# Access Compliance Report

### (Curb Ramps)

Intersection ID: 3908	Main Street: BULLE_ROCK_CT	Cross Street: WOODCOCK_LN	Location: NE
ADA ID: D32CAD97DE9E	Ramp Type: Perp	Initial Pass/Fail: Fail	Overall Compliance: No
Severity Score: 1.25			
Codes/Mitigation Info/Possible Solution		Field Measurements/Component Compliance

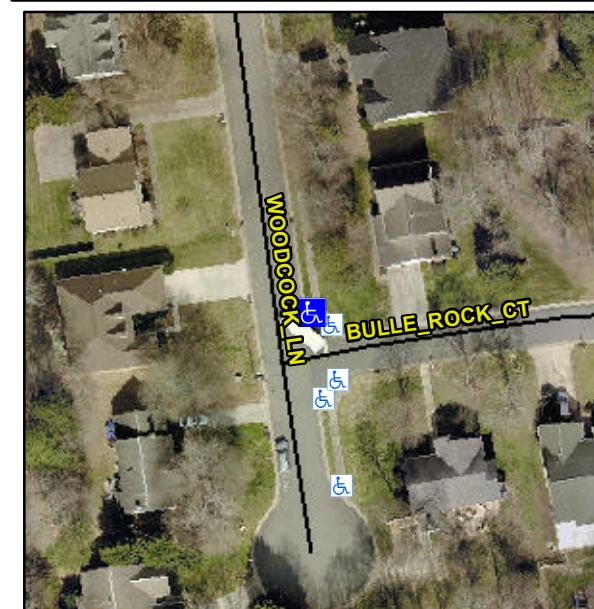
**Remove & Replace Entire Ramp.**

**R304.5.3**

Compliance	Description	Data	Compliance	Description	Data
N/A	Ramp Length (in)	46.0	Yes	Ramp Slope (%)	6.4
Yes	Ramp Width (in)	55.0	No	Ramp XSlope (%)	2.3
N/A	Flare Type LT	N/A	N/A	Flare Type RT	N/A
N/A	Flare Slope LT (%)	N/A	N/A	Flare Slope RT (%)	N/A
N/A	Flare Traversable LT?	N/A	N/A	Flare Traversable RT?	N/A
N/A	Landing Length (in)	N/A	N/A	DWS Provided?	N/A
N/A	Landing Width (in)	N/A	N/A	DWS Contrast?	N/A
N/A	Landing Slope (%)	N/A	N/A	DWS Length (in)	N/A
N/A	Landing X Slope (%)	N/A	N/A	DWS Full Width?	N/A
N/A	Landing Curb? (Y/N)	N/A	N/A	DWS Offset (in)	N/A
N/A	Shared Landing?	N/A			
N/A	Gutter Ponding?	N/A	N/A	Gutter Slope (%)	N/A
N/A	Gutter Lip Ht (in)	N/A	N/A	Gutter X Slope (%)	N/A
N/A	Painted X Walk1?	No	N/A	Painted X Walk2?	N/A
	X Walk 1 Direction	To W		X Walk 2 Direction	N/A
N/A	X Walk 1 Width (in)	N/A	N/A	X Walk 2 Width (in)	N/A
	X Walk 1 Slope (%)	4.1		X Walk 2 Slope (%)	N/A
	X Walk 1 X Slope (%)	0.2		X Walk 2 X Slope (%)	N/A
